MIT CSAIL	77 MASSACHUSETTS AVENUE RM 32-380 CAMBRIDGE, MA 02139	
Drawn by: Dan @ 617-504-9619		
n11-neck-pot-holder		
Quantity: 1 piece		Scale:1:1
Material:	Finish:	1/1

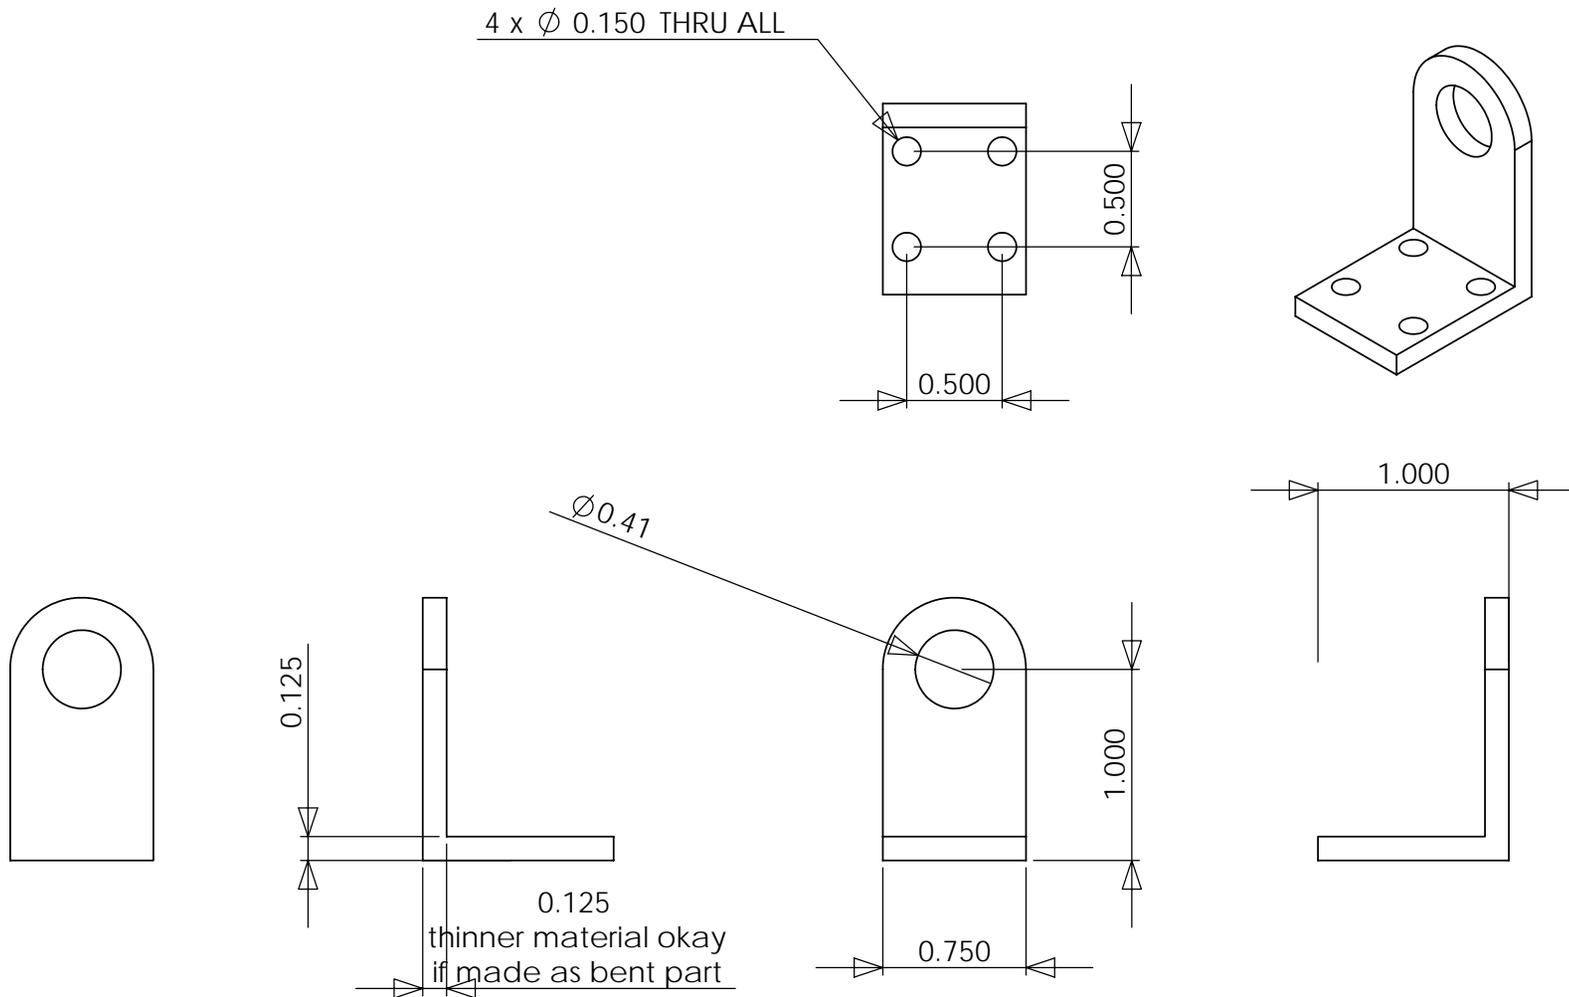
use stock angle or make as bent sheet metal part.
0.06 thickness is fine.
